RE: ACKNOWLEDGEMENT OF RECEIPT OF ADDENDUM NO. 3

ADDENDUM NUMBER 03

PROJECT: **MIB RENOVATIONS**
REID STATE TECHNICALCOMMUNITY COLLEGE
GMC PROJECT NO. ABHM250047

A1.04

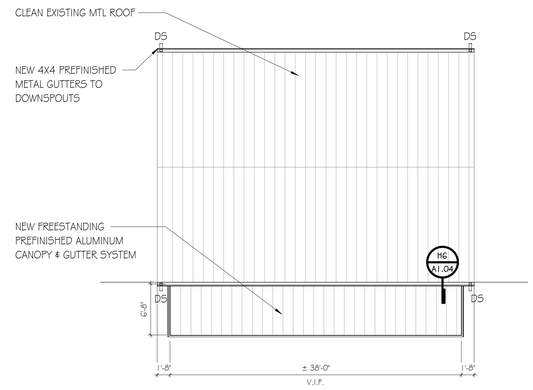
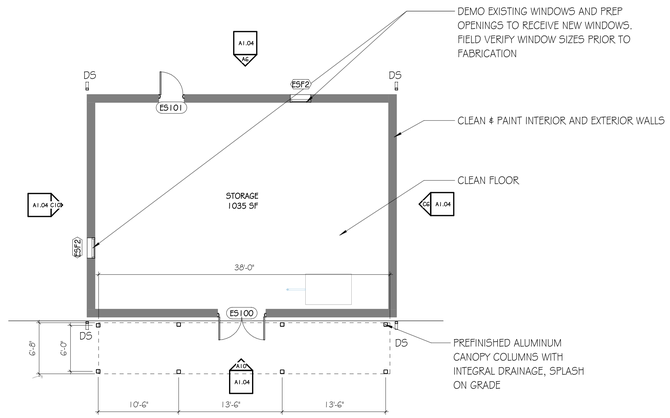
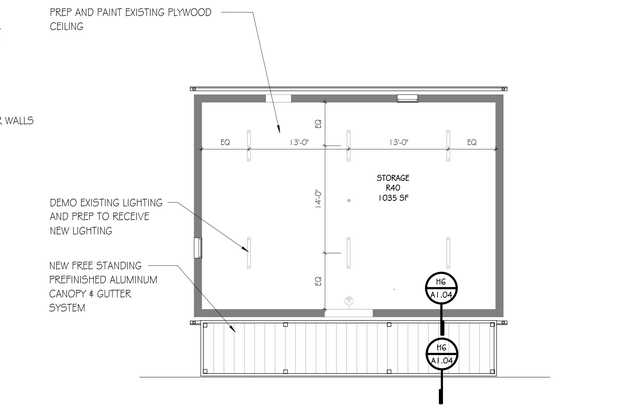
C. Reference Revised **Sheet A1.04 – STORAGE BUILDING PLAN, RCP & ROOF PLAN** and replace with attached revised sheet.
   i. Existing roof conditions clarified and new canopy extents modified. Existing door and window locations modified to match existing conditions.

9	HH	Storage Building Elevations / Opening Locations Refer to Sheet A1.04, Elevations A6 and A10. The elevations appear to show the windows and door on the gabled ends of the Storage Building; however, based on existing conditions observed in the pre-bid meeting photos, these openings appear to be located on the long sides of the existing building, and the elevations do not appear to match the existing building configuration. Please clarify the correct elevation layout and intended locations for the Storage Building windows and door.	3	Drawings were updated to accurately reflect the existing conditions.
10	HH	Replacement Window Type Refer to Sheet A1.04. The plan shows two existing windows to be replaced with new windows; however, the required replacement window type/system is not clearly indicated. Please clarify whether these two replacement windows are to be aluminum-framed storefront assemblies, manufactured window units, or another window system.	3	Manufactured window units.

REFLECTED CEILING PLANS

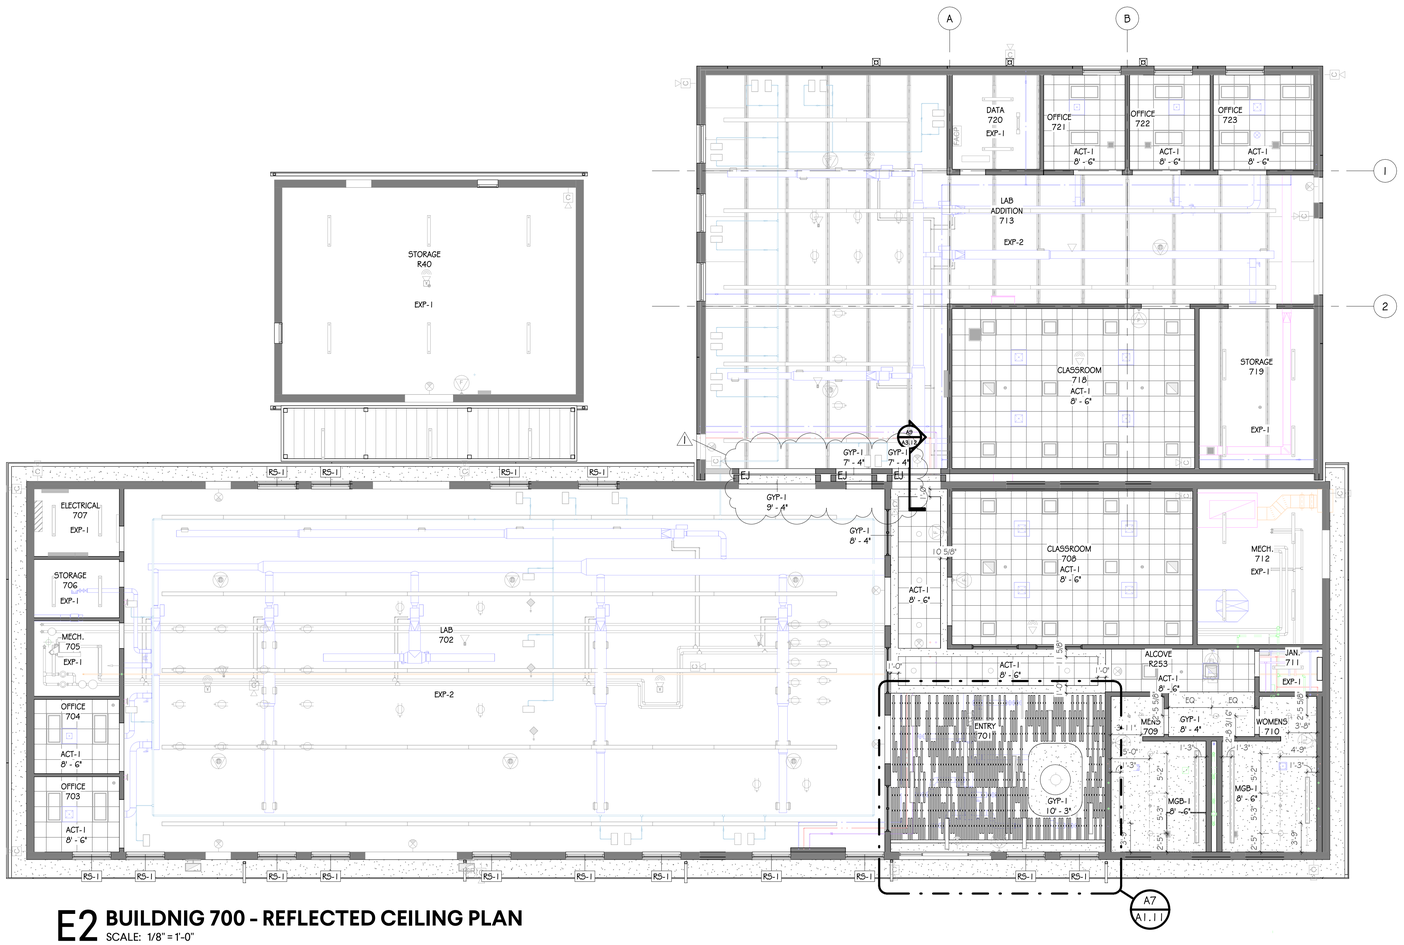
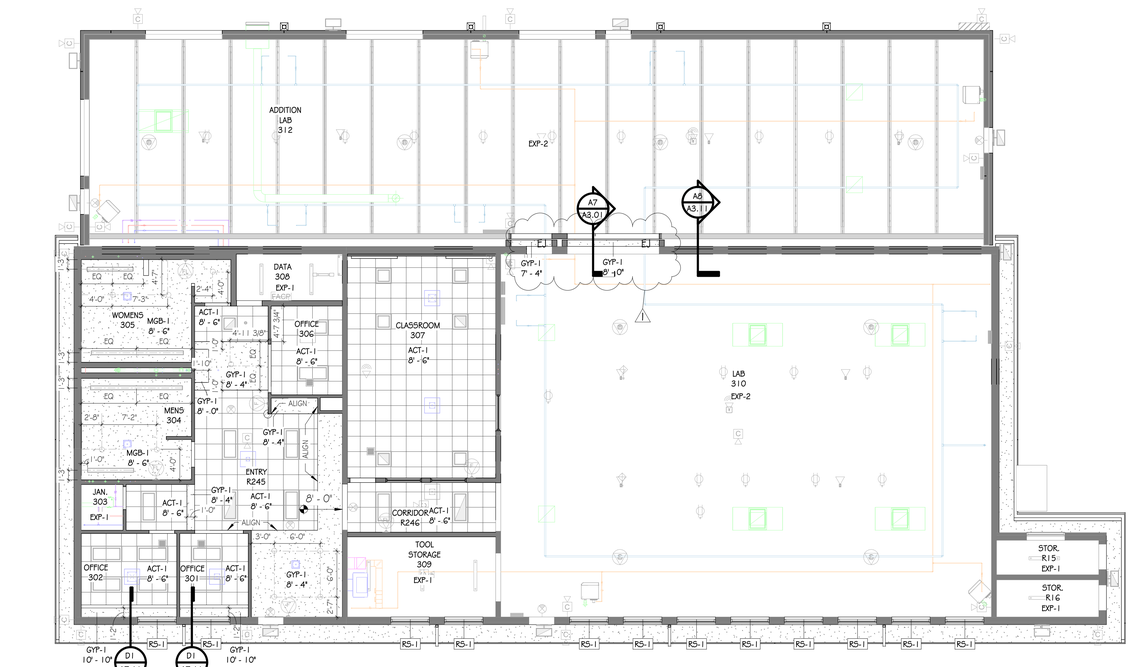
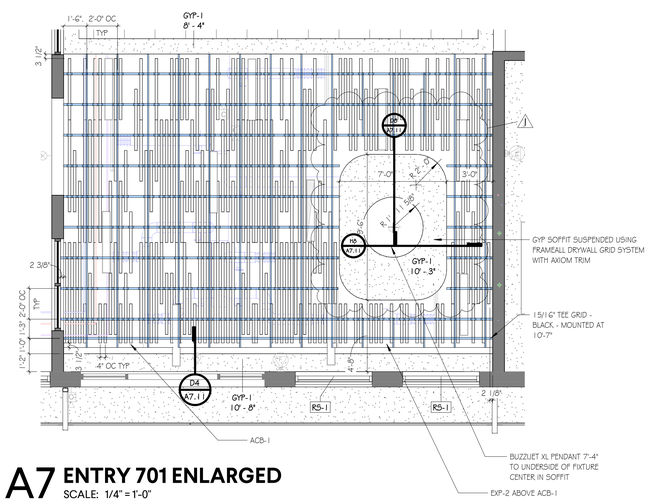
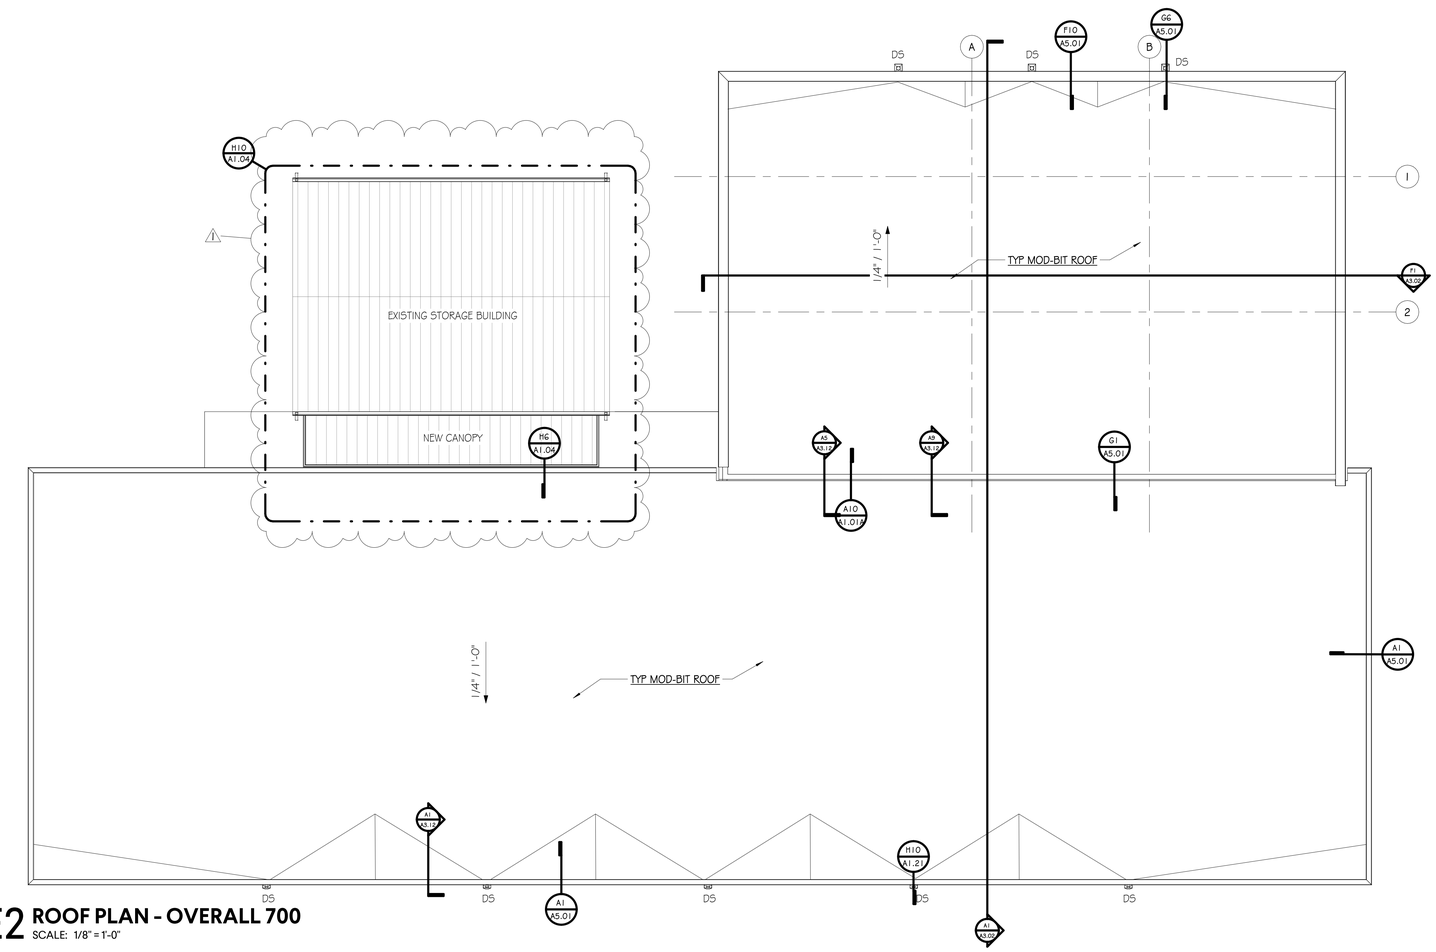
D. Reference Revised **Sheet A1.11 – REFLECTED CEILING PLANS** and replace with attached revised sheet.
   i. Added section details markers to suspended gyp soffit in Entry 701 Enlarged Plan. Identified expansion joint cover at gyp ceilings.

ROOF PLANS

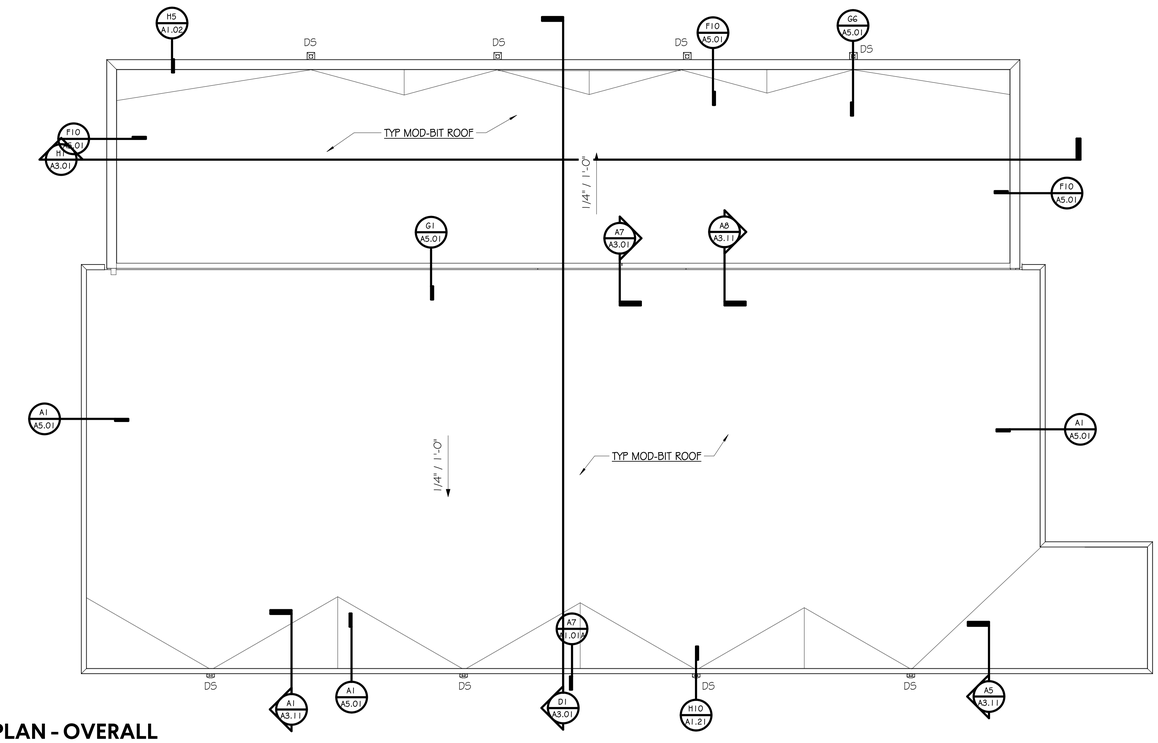
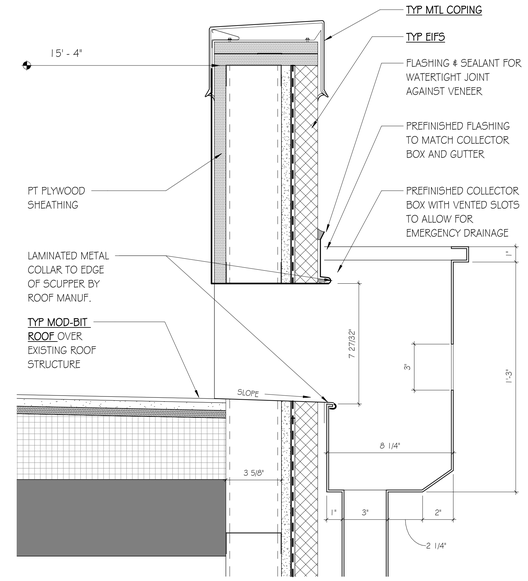
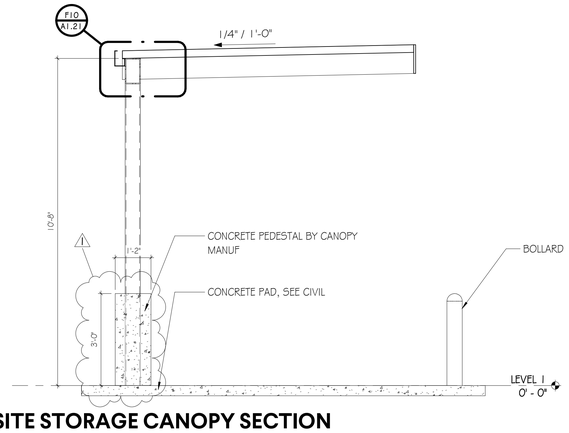
E. Reference Revised **Sheet A1.21 – ROOF PLANS** and replace with attached revised sheet.
   i. Existing roof and new canopy for storage building updated to match updated information provided per sheet A1.11.

A2.01

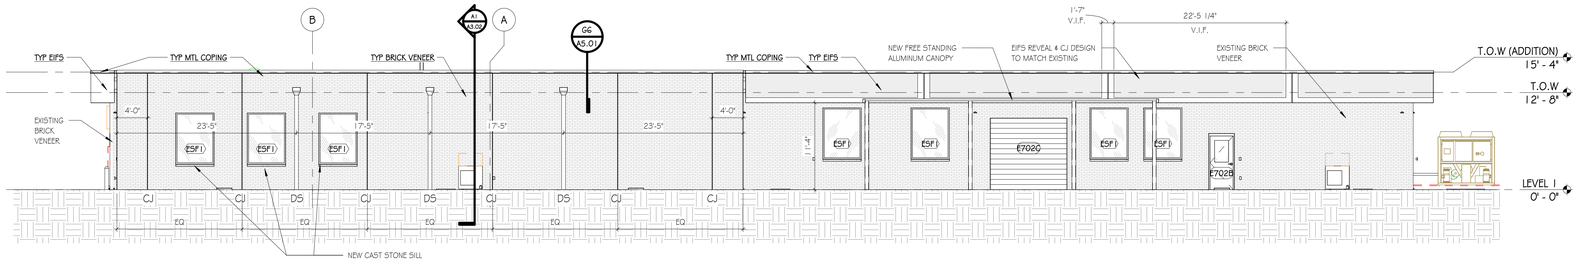
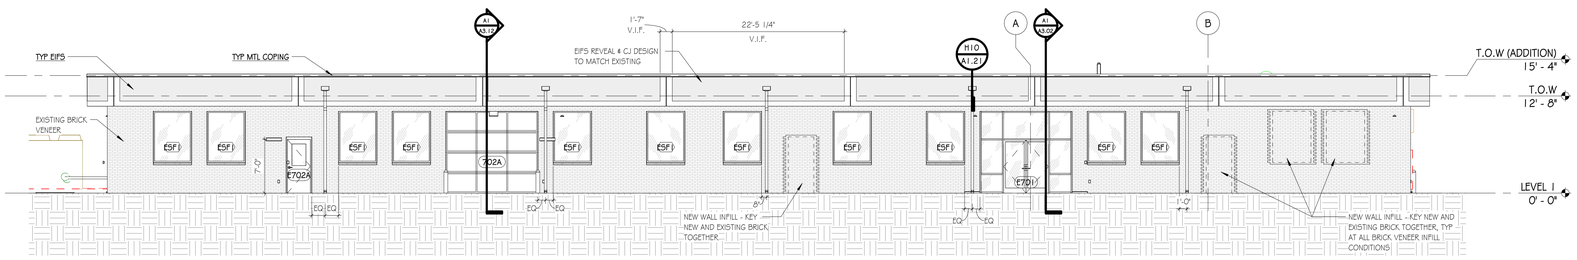
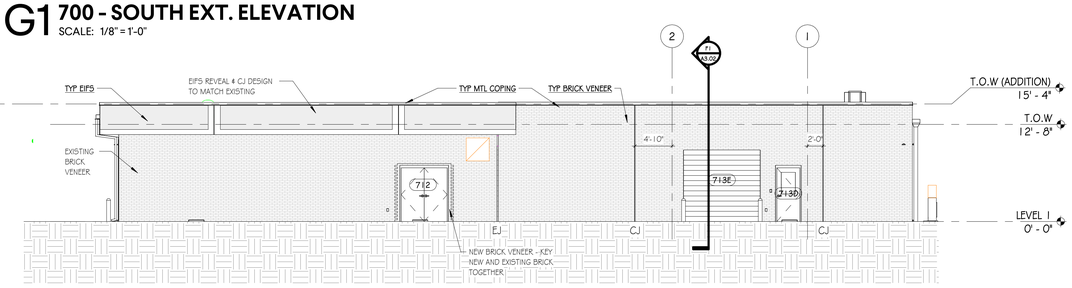
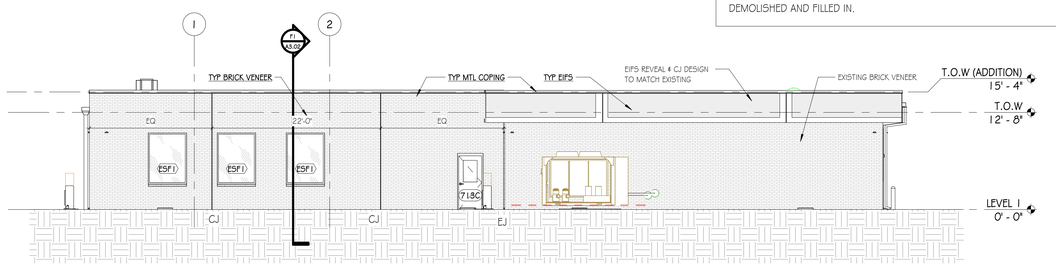
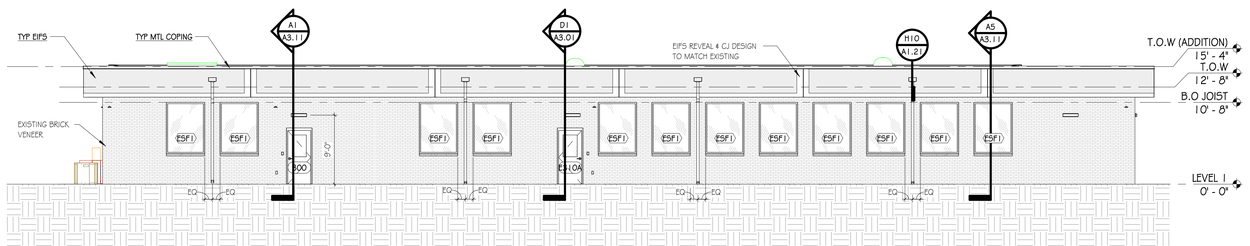
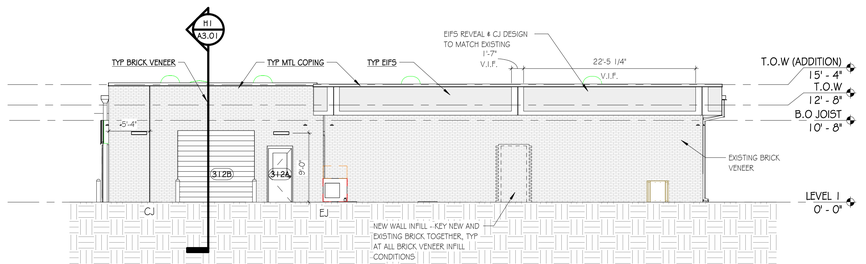
F. Reference Revised **Sheet A2.01 – EXTERIOR ELEVATIONS** and replace with attached revised sheet.
   i. Stone window sills, EIFS profiles, and extent of new brick indicated.

G1 EXPANSION JOINT @ ROOF
SCALE: 3" = 1'-0"

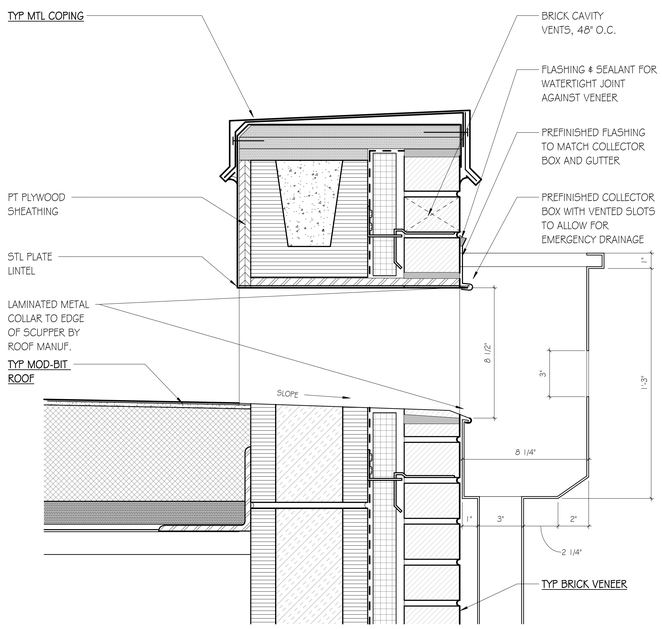
5	HH	Expansion Joint at Roof Detail G1 Existing Overhang Modification Refer to Expansion Joint at Roof Detail G1 on Sheet A5.01 and the demolition plans on Sheet A1.01. Detail G1 does not appear to indicate how the existing slanted metal soffit and overhang condition is to be modified or demolished to accommodate the new building additions, and this condition does not appear to be shown on the A1.01 demolition plans. Please provide details clarifying how the existing slanted metal soffit and overhang conditions are to be modified to accept the new design intent shown in Detail G1.	3	See new sheet A1.01A for demolistion plans and details at expansion joint.
6	HH	Refer to Landscape Sheet L1.01 and Details 5 and 6 on Sheet L2.01. Sheet L1.01 calls for Ameristar Montage II ornamental fence, and Details 5 and 6 on Sheet L2.01 are labeled as Ameristar Montage II fence; however, the detail information appears to reference differing Ameristar fence grades, including Montage Industrial and Montage Plus, with differing picket, rail, and post sizes. We also do not see clarification indicating whether the fence is to be 3-rail or 4-rail, or confirming the required fence color/finish. Please confirm the required Ameristar fence grade, fence height, component sizes, rail configuration, and color/finish to be provided for the ornamental fence	3	See updated drawings

A1 SOFFIT DETAIL
SCALE: 3" = 1'-0"

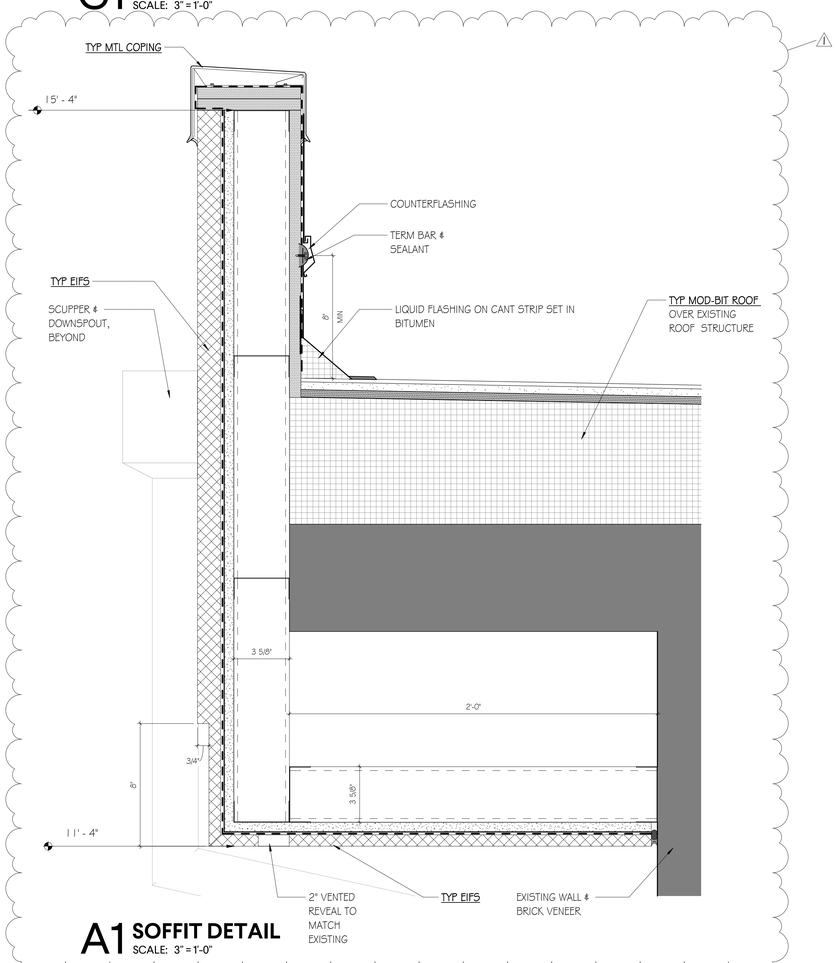
G. Reference Revised **Sheet A5.01 – SECTION DETAILS** and replace with attached revised sheet.
   i. EIFS profile indicated to match existing.

3	HH	Soffit Detail A1 Material Layers and Framing Refer to Soffit Detail A1 on Sheet A5.01. The detail appears to show multiple layers of materials and/or sheathing in addition to the EIFS assembly at the soffit, fascia, under coping, and behind the parapet; however, the required materials for each layer and the associated metal framing descriptions and spacing are not clearly indicated. Please clarify the required material build-up for each layer at these conditions and provide the required metal framing sizes, gauges, and spacing.	3	Refer to G series sheet for all typical build-up of standard assemblies. Updated soffit detail also provided.
4	HH	Existing Soffit/Fascia Condition vs. New Soffit Detail A1 Refer to Soffit Detail A1 on Sheet A5.01 and the existing soffit and slanted metal fascia conditions. The existing metal soffit and slanted metal fascia condition does not appear to match the new Soffit Detail A1 condition, and we do not see where the existing soffit and slanted metal fascia are indicated to be demolished or modified to accommodate the new detail. Please clarify the required demolition and modification scope for the existing soffit and slanted metal fascia at these locations.	3	See new sheet A1.01A for demolistion plans and details at existing metal facia/soffit.

A6.03

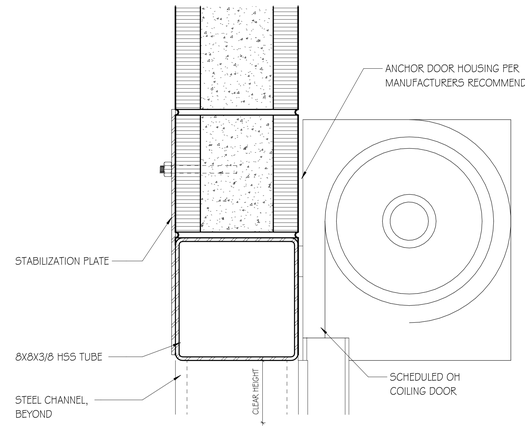
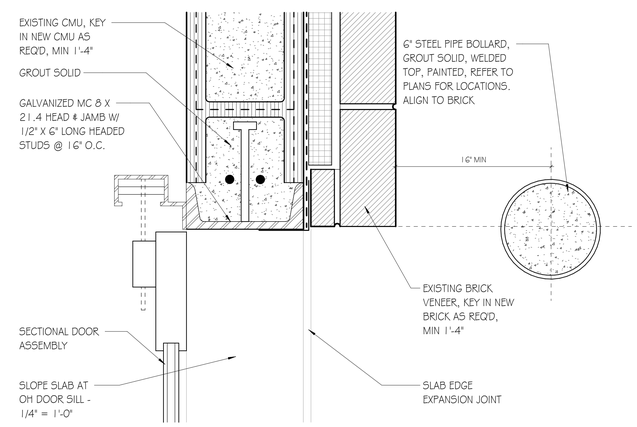
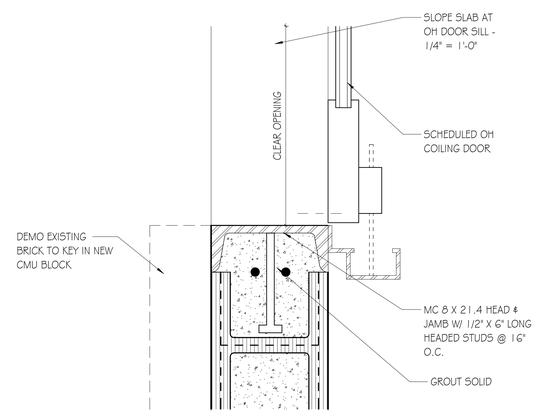
I. Add New **Sheet A6.03 – DOOR DETAILS**.
   i. New overhead door details for existing walls.
